MCGB-Ø16~Ø32 Plate

MCGB-Plate will have following design change.

MCGB-Ø16~Ø32 Plate

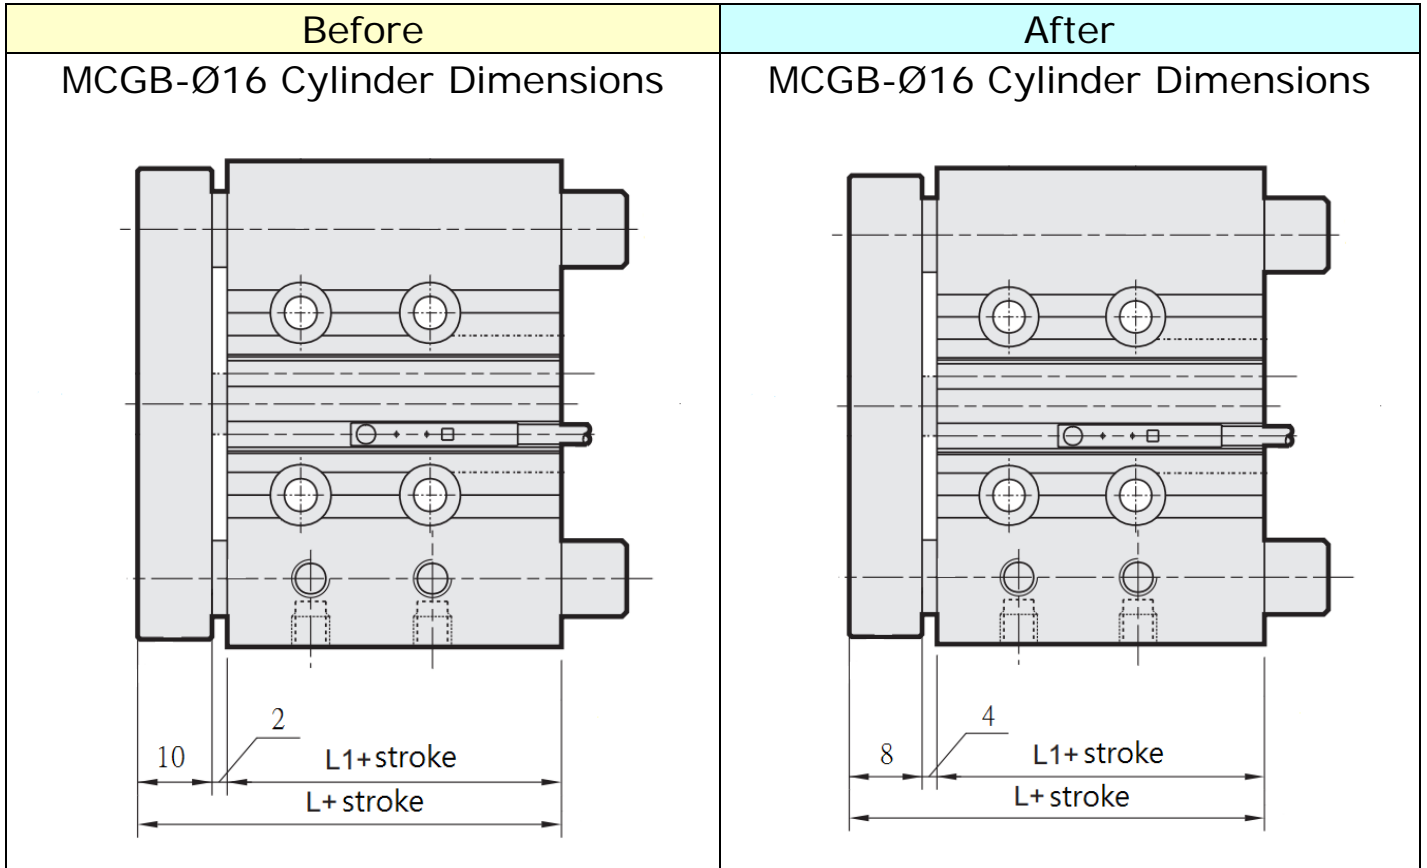
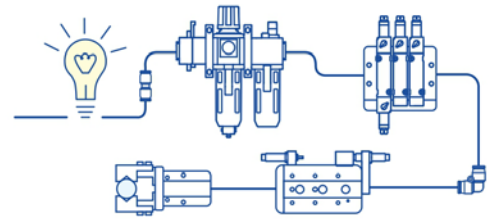
Change the profile dimension of plate into the same size as the plate of MCGS to lower the stock cost.

The mounting hole size and locations remain the same.

Model	A	B	C		Model	A	B	C	
Ø16	25	62	10		Ø16	25	62	8	
Ø20	30	72	10		Ø20	30	81	10	
Ø25	38	86	10		Ø25	38	91	10	
Ø32	48	112	12		Ø32	44	110	12
